OFFICIAL NOTICE AND AGENDA
Pardeeville Plan Commission Regular Meeting
Pardeeville Village Hall – Board Room
114 Lake Street, Pardeeville, WI 53954
Tuesday, March 19, 2024 – 6:00 PM

Public Works Director Memo

Topic: Sunrise Subdivision

To: Village of Pardeeville Village Board
From: Joe DeYoung, P.E.; Brad Vowels-Katter, Associate Planner
Subject: Sunrise Subdivision, Lots 17-19 PUD GDP Review
Date: Tuesday, March 12, 2024

PROJECT NO:	2024-110 (B)
DATE:	1/05/24
DESIGNED BY:	RJR
DRAWN BY:	WAC
SHEET:	C 2.0

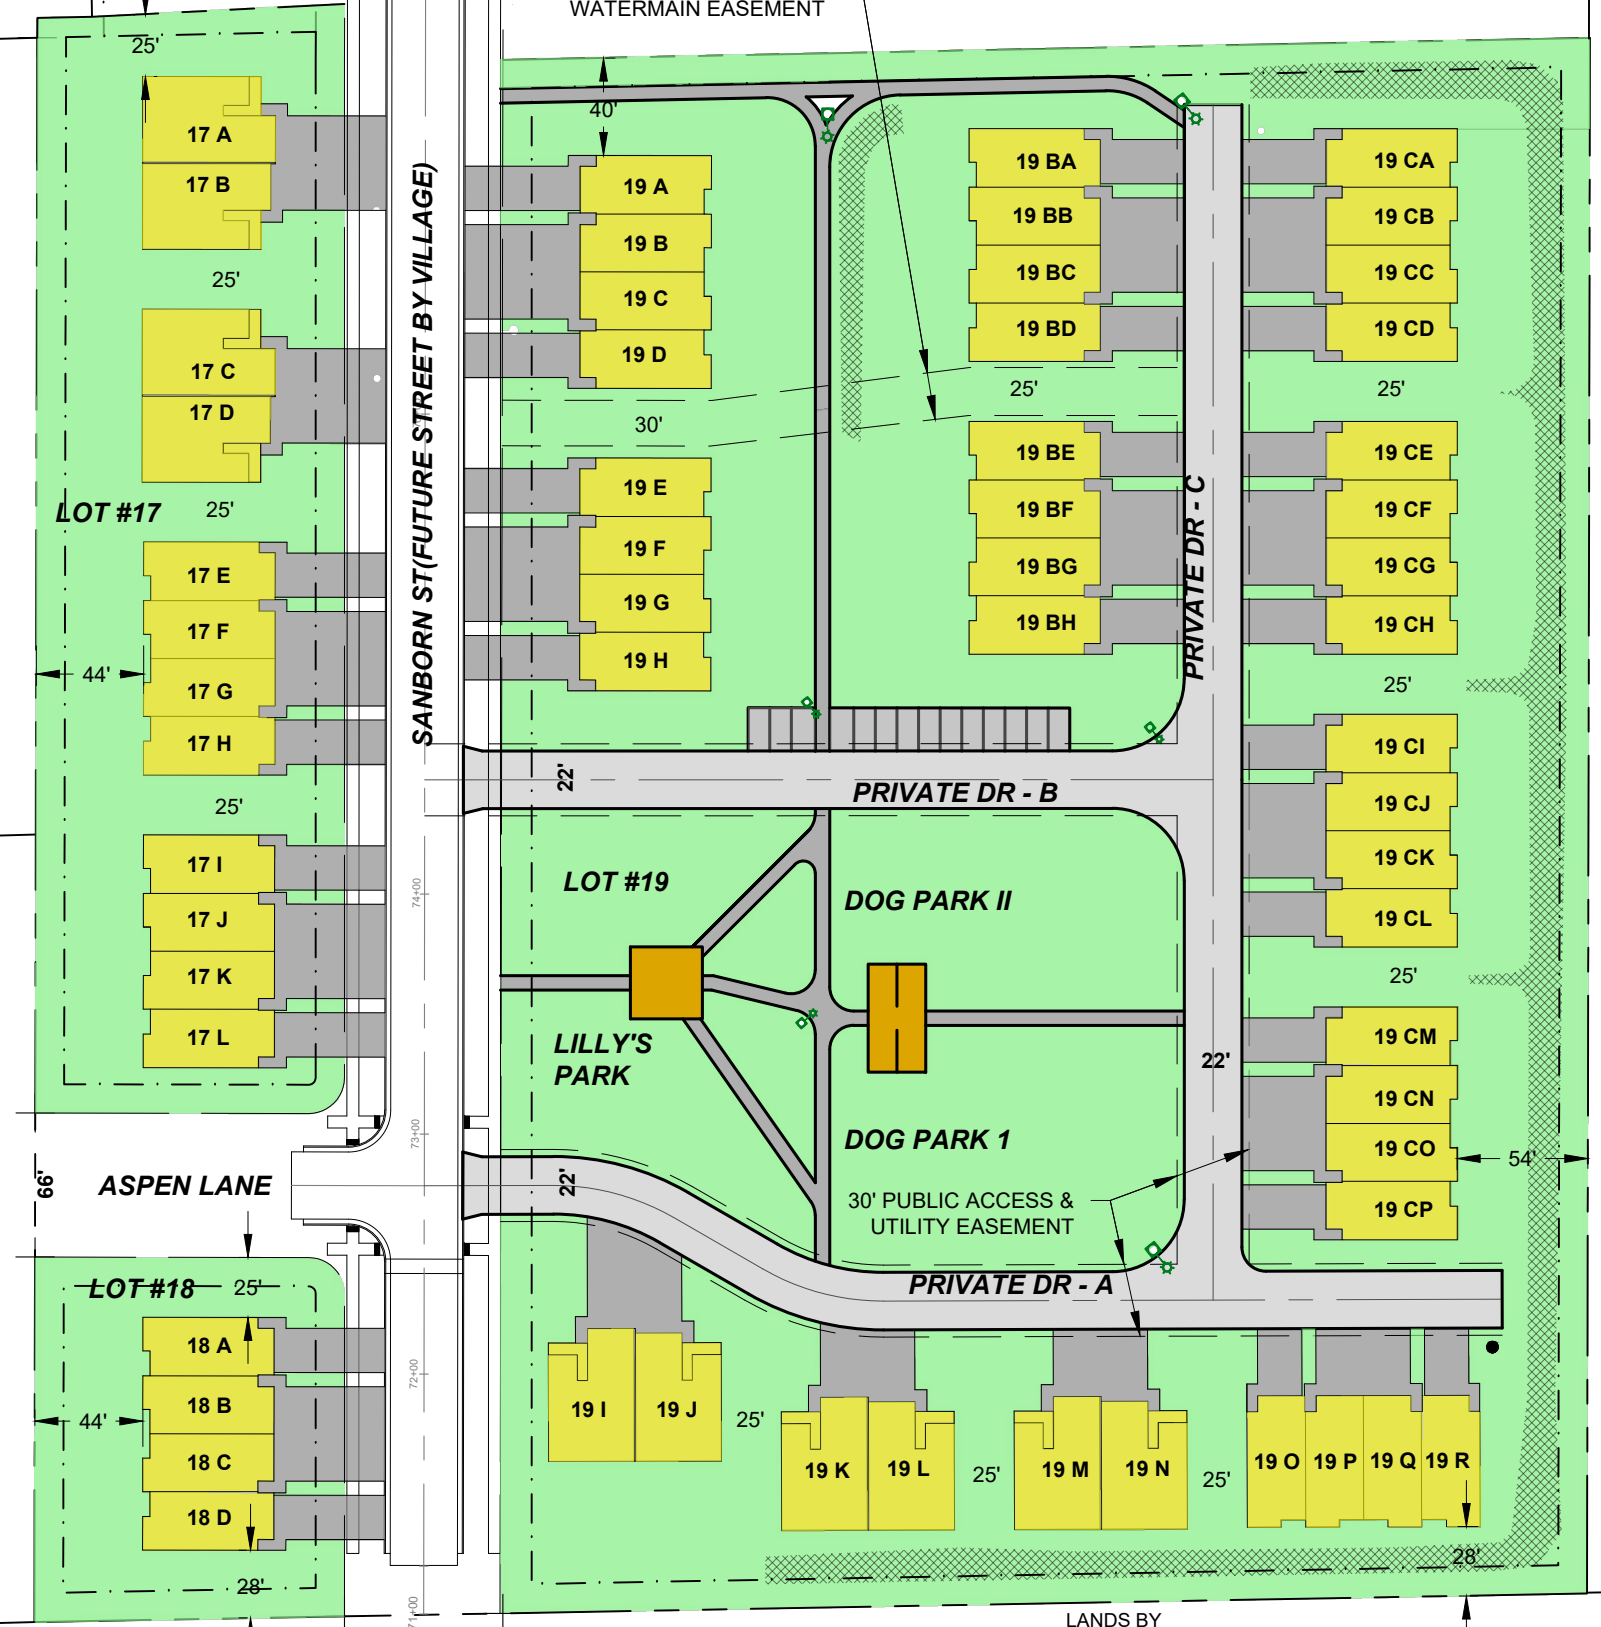
Sheet C 2.0 is the overall concept map of the sites. Lot 17 has a mixture of duplexes and fourplexes (townhomes). Lot 18 is a single fourplex. Lot 19 is another mixture, but predominantly fourplexes. Lot 19 also has, depicted in the central bottom, a dog park named Lilly's Park. Overall, the concept is very aesthetically pleasing. The developer is utilizing the space to balance improvements and green space, and it looks, on paper, like a good balance. Likewise, the inclusion of a small park is a nice feature. The governing body may like to get, in writing, the maintenance agreements of how the grass will be mowed and especially how the park will be maintained. There is no indication that the park will be public, so there should be some written acknowledgement of maintenance. Likewise, as discussed at the meeting, the overflow parking on the north side of Private Drive – B, is to be moved to the south side of that private drive to account for parking and usage for the park. There is a watermain easement between Private Drive – B and the northern most lot line but the comment from staff will appear in the next section, the utilities sheet. Next, nowhere on the plan is a location for solid waste. The body should not accept any plan without having a designated location for that in this instance. The issue could quickly arise where, if no location is designated, the residents in this area could be leaving their trash bins/dumpsters next to the road which is not what the Village wants. Likewise, no winter maintenance plan is depicted regarding the dead-ends of the private drives. Finally, given the driveway topic later in the Plan Commission agenda, it should also be discussed if this concept plan should be allowed to have fluidity in the driveway placements. For instance, the duplexes 19-I and 19-J, could be allowed to turn 90 degrees to have driveway access off of Sanborn Street. However, staff is hesitant to allow that for other buildings on the concept plan.

PROJECT NO:	2024-110 (B)
DATE:	1/05/24
DESIGNED BY:	RJR
DRAWN BY:	WAC
SHEET:	C 2.1

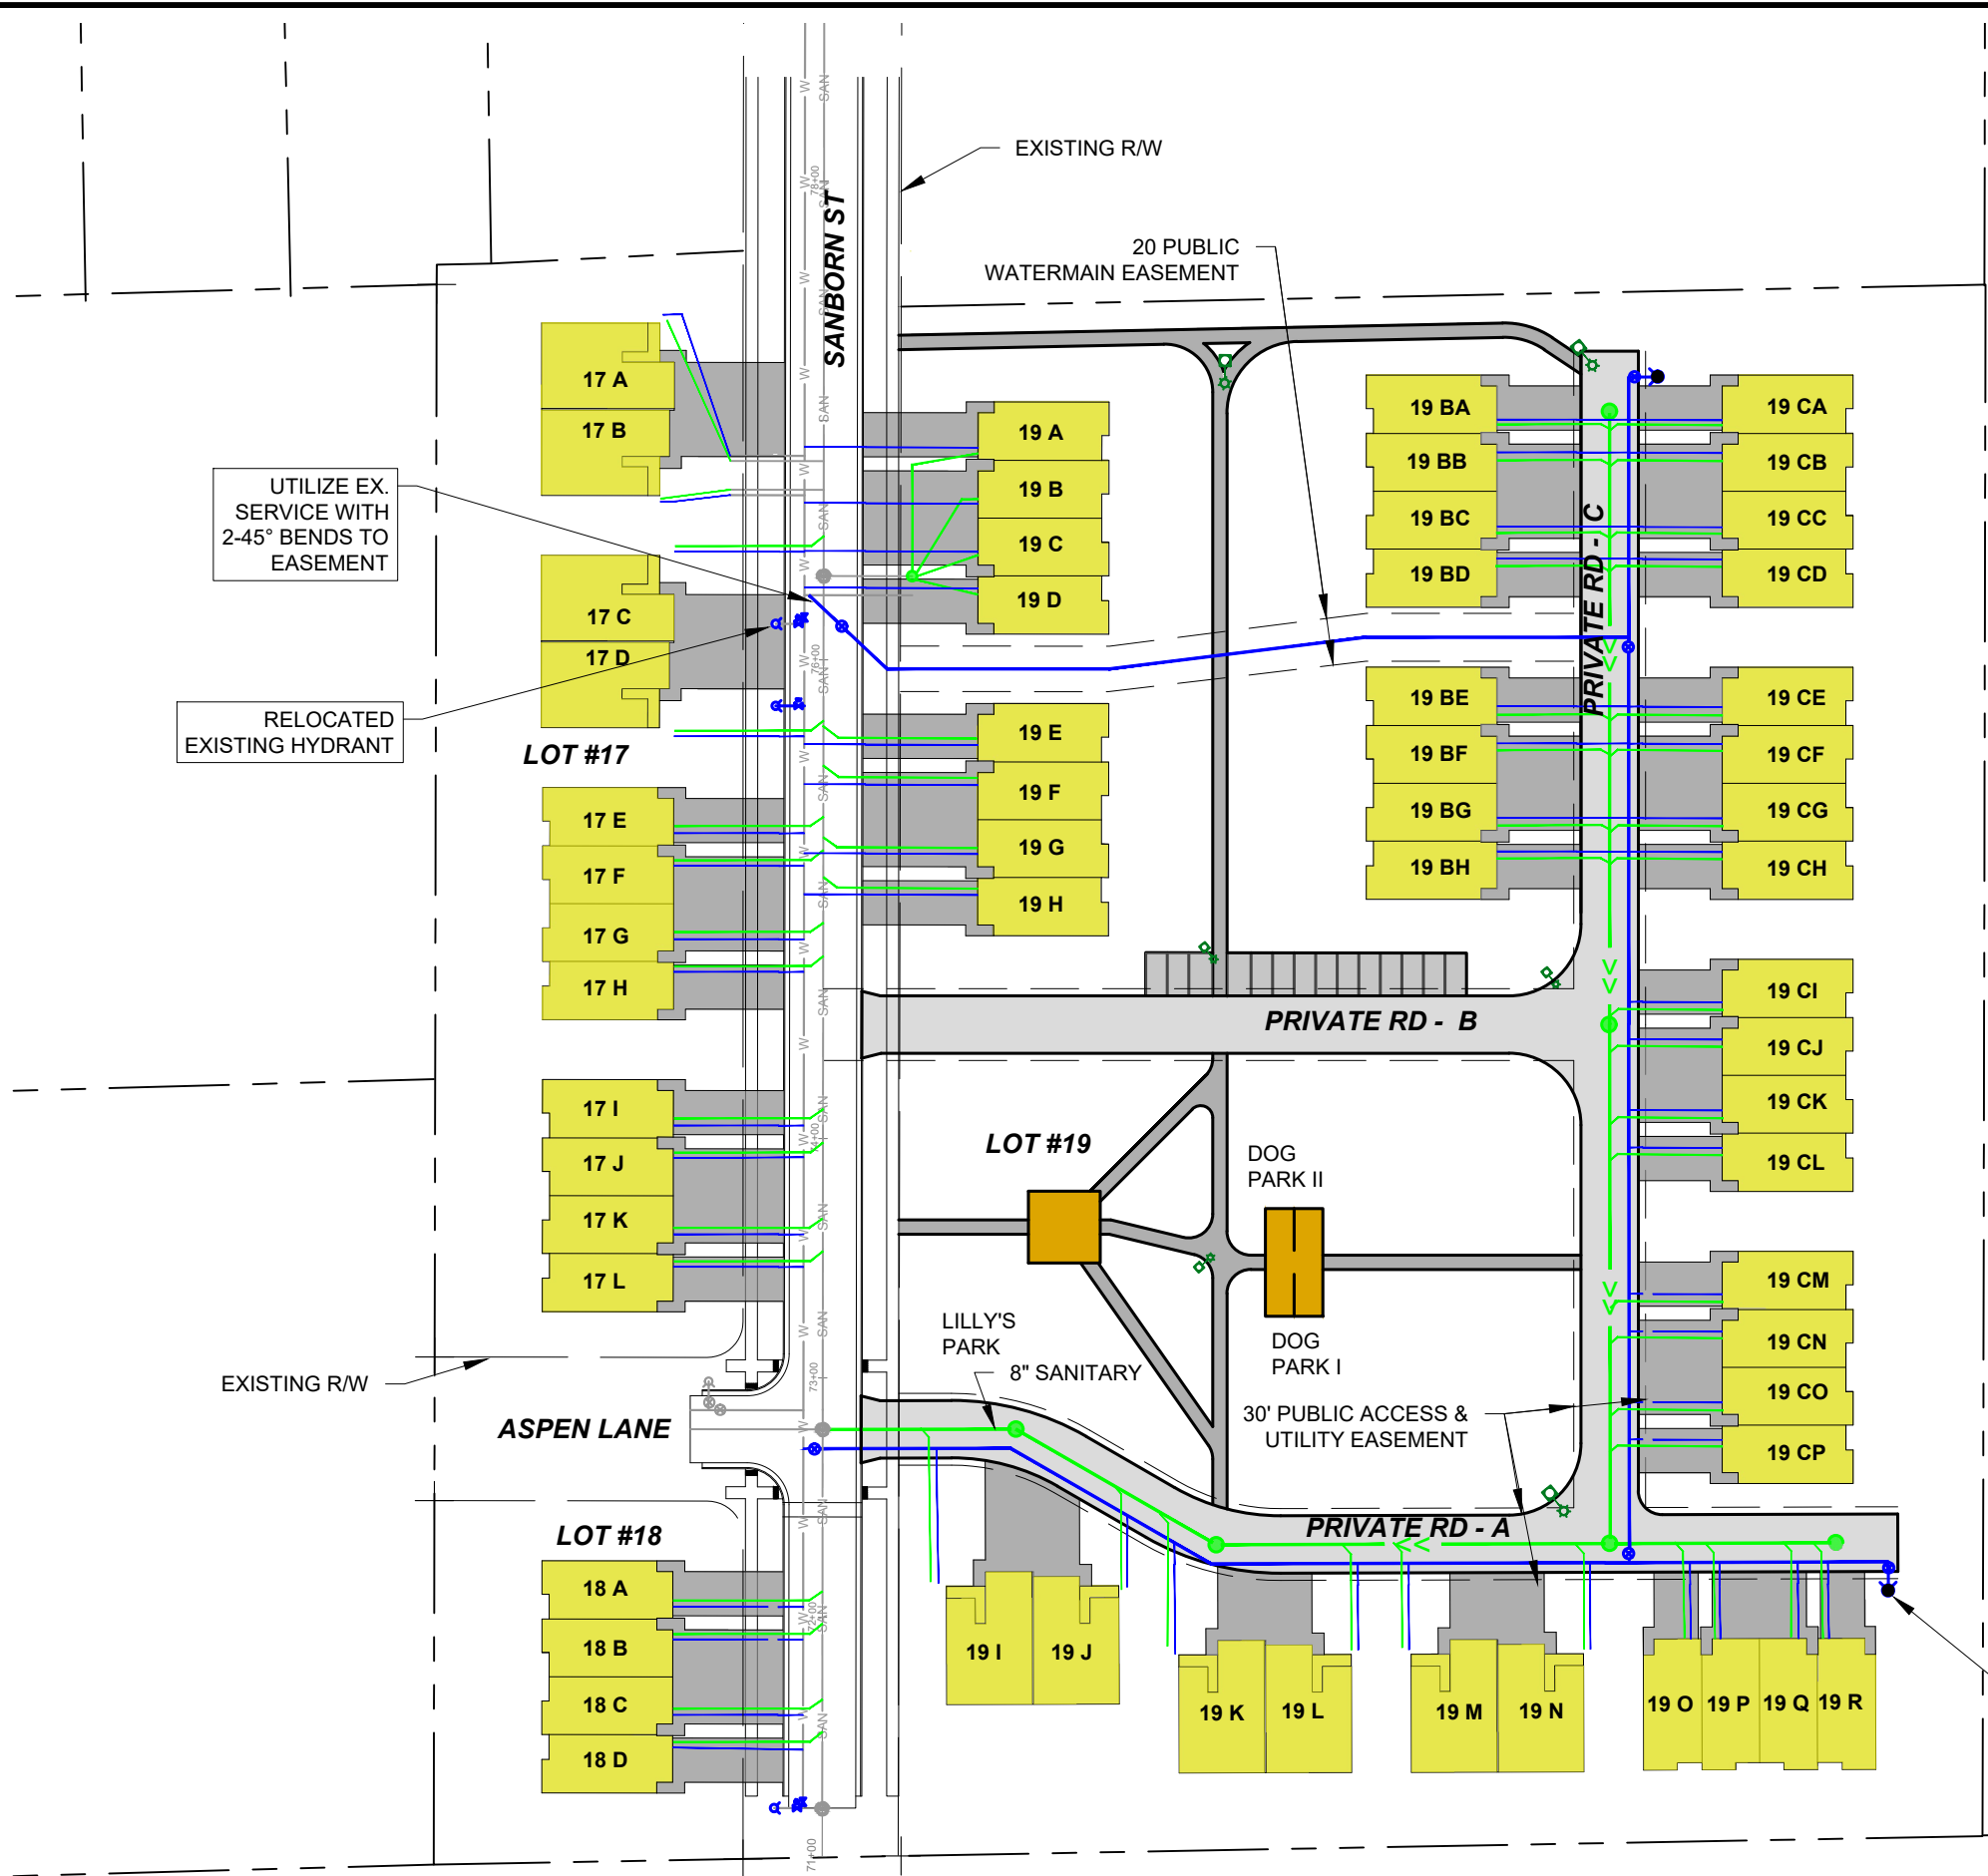
Looking at sheet C 2.1, the water and sewer utilities are displayed. Stormwater and electric are not displayed on this sheet. Stormwater is covered in the next sheet; however, electric is never discussed. Staff is, given the shortcomings in the first phase, requesting that electric be displayed. This will limit the extra infrastructure the Village will need to put in. The Village will have to install several new laterals/services to lots 17 and 18 due to the concept changing to more dense improvements. The sewer is deep enough on Sanborn Street that normal flow should be enough to allow gravity fed sanitary sewer for this addition. The watermain easement as mentioned prior is unbeneficial to the Village in its

current placement. Staff believes shifting the fourplex 19-A, 19-B, 19-C, and 19-D north to realign the easement is more beneficial to the Village and will eliminate the extra water main being furnished in the road, as there is an existing watermain stub there. This may result in slight reworking of the walking path on the north side, or even an elimination of that northern leg (not the entire path). Likewise, another option could be to switch this to duplexes. Ultimately, that would be the developer's decision, however, the body could require the stub to be used instead of the proposed new main and valve.

SHEET: C 2.2

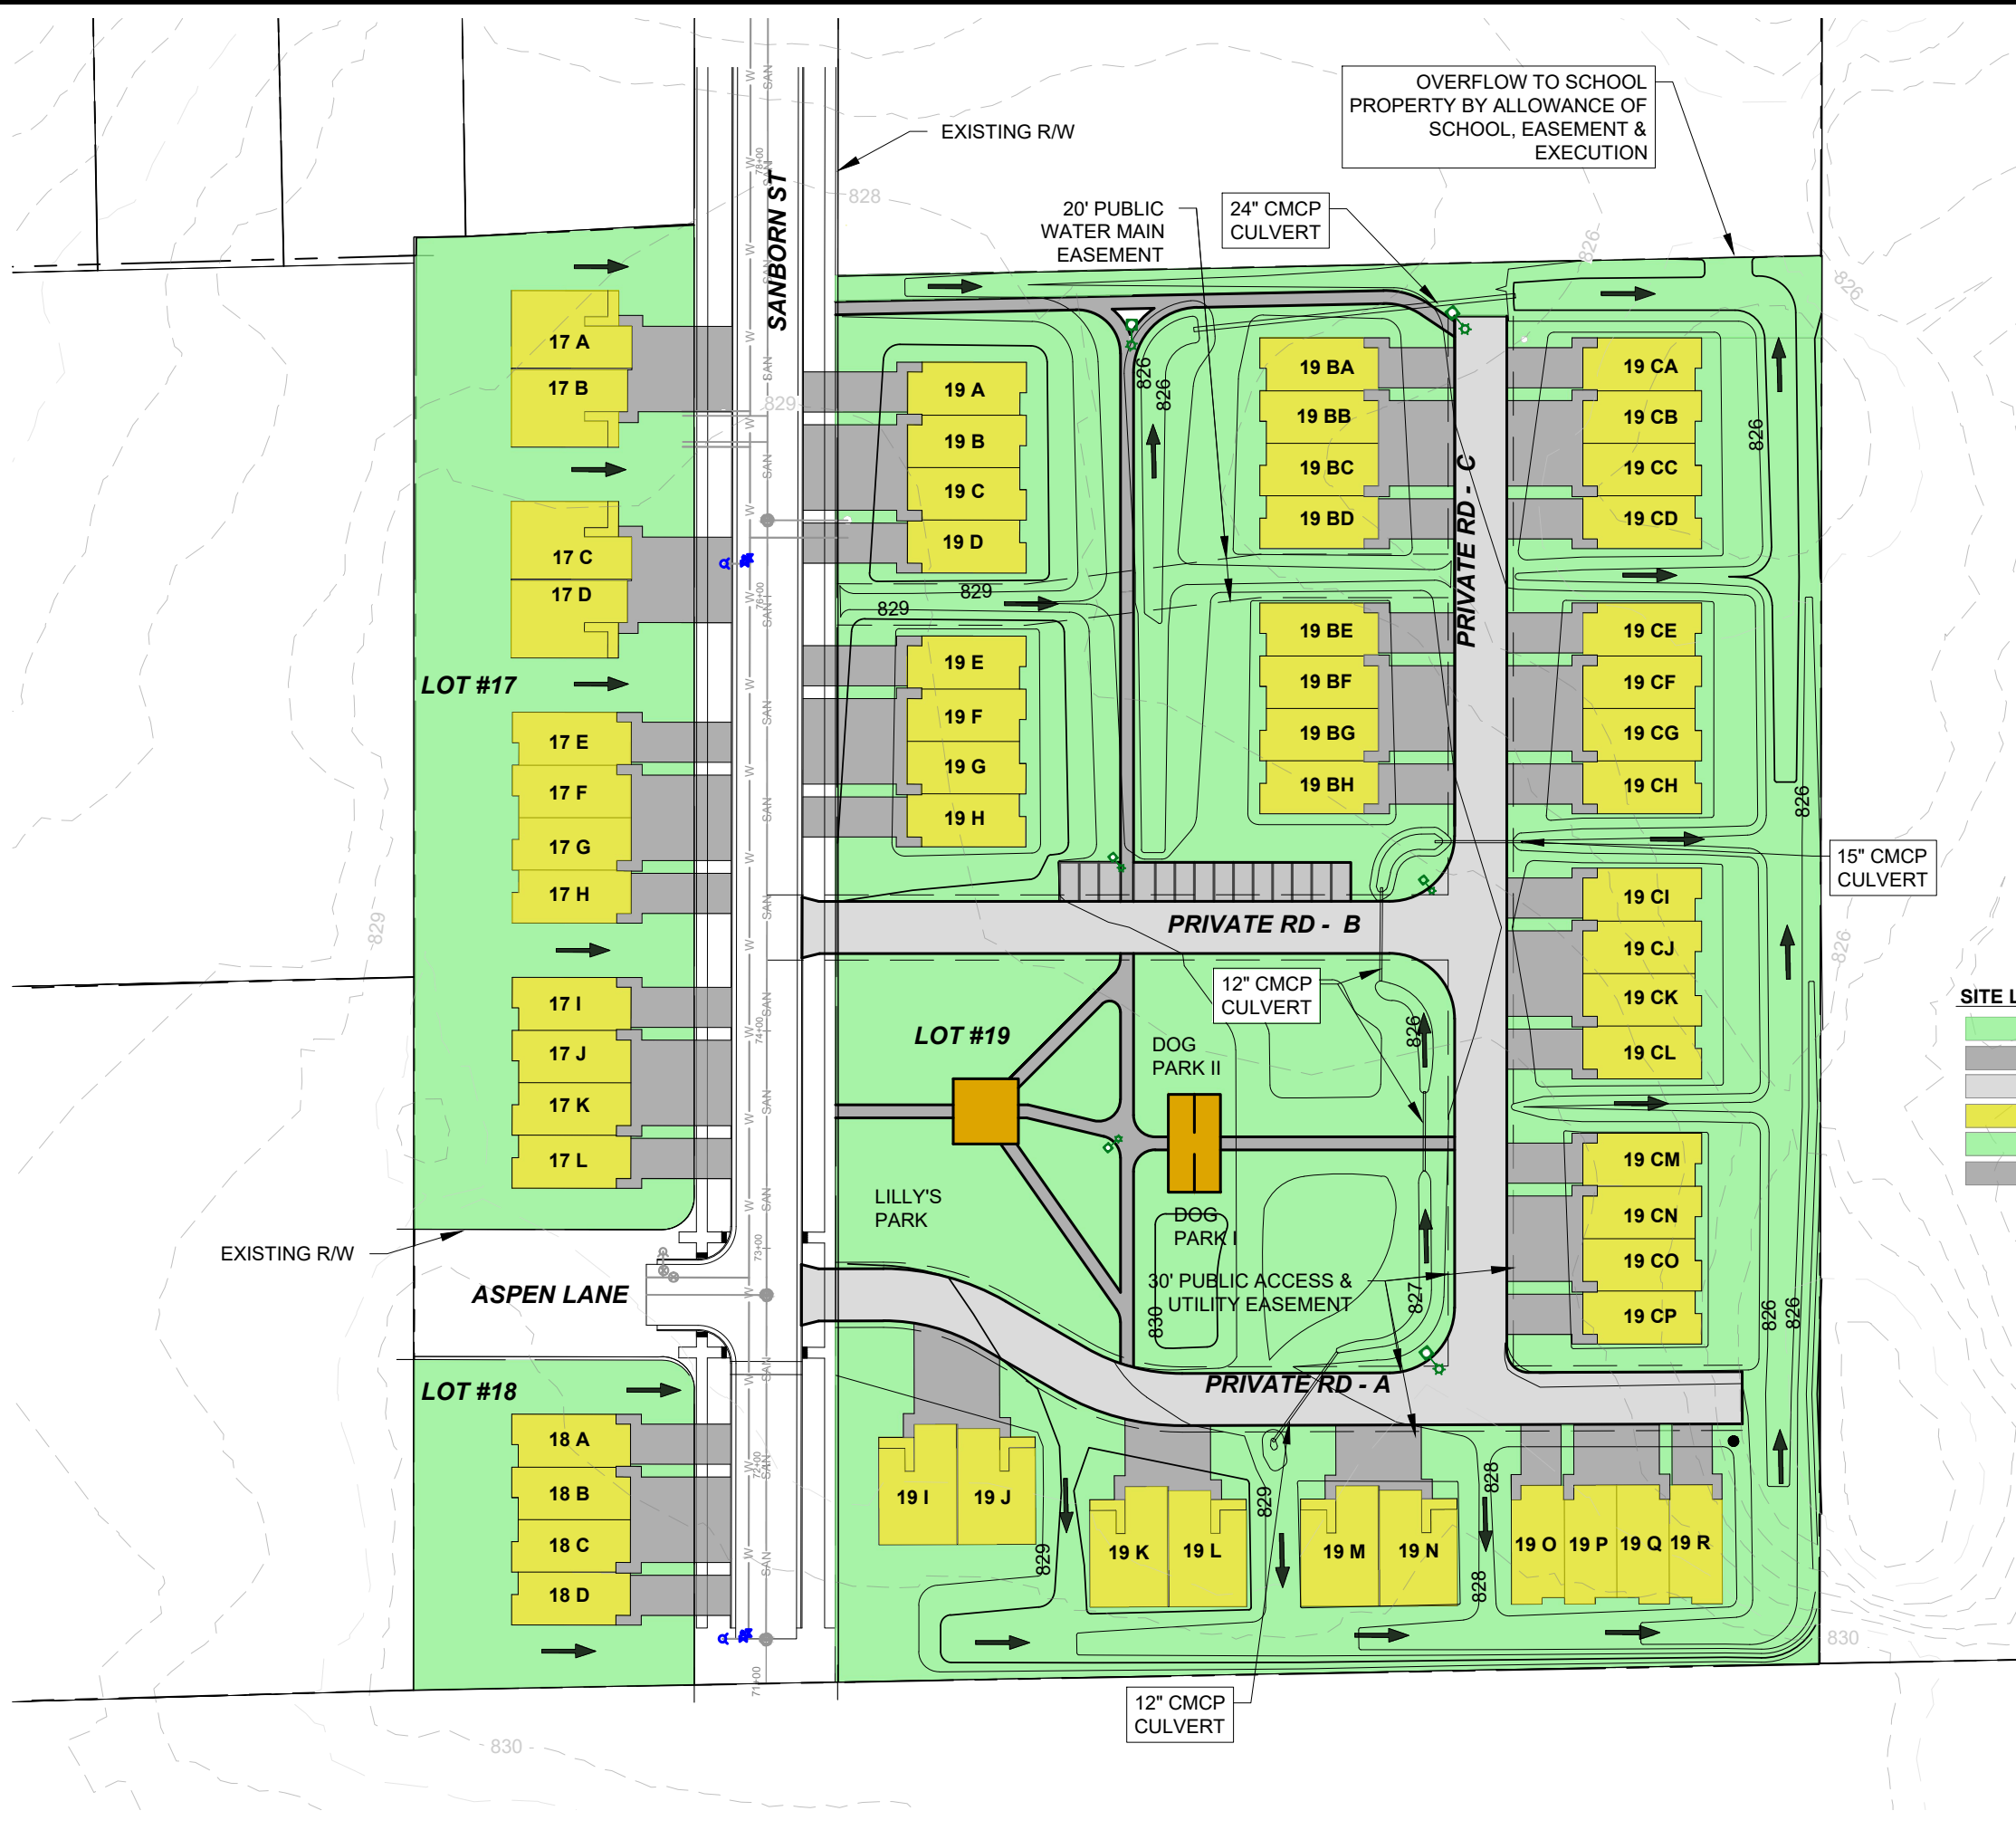
Looking at sheet C 2.2, the drainage plan of the three lots are displayed. Lot 17 and 18 show sheet flow up to the roadway. Lot 19, conversely, has an intricate ditch and swale system to flow stormwater away from the road to the north east corner of the lot. Originally, the plan shows stormwater dumping onto the church lot, however, an agreement was secured prior to the new administration to route water onto the School Districts land to reach the Village owned pond. This change was noted at the meeting and will be updated going forward. One of the only comments staff has on this sheet regard the maintenance of the ditches/swales, similar to the grass mowing and winter maintenance. If the swales and ditches are not maintained, it could lead to water pooling, back up, mosquito havens, foul smells, or spillage onto the Village's ROW. This leads into staff's other comment. There is no storm sewer indicated on the plan. This may not be needed due to the elevation changes on site, which may allow the gutter to convey all stormwater, but the note must still be made as there is nothing in writing indicating the quantity of stormwater is being managed.
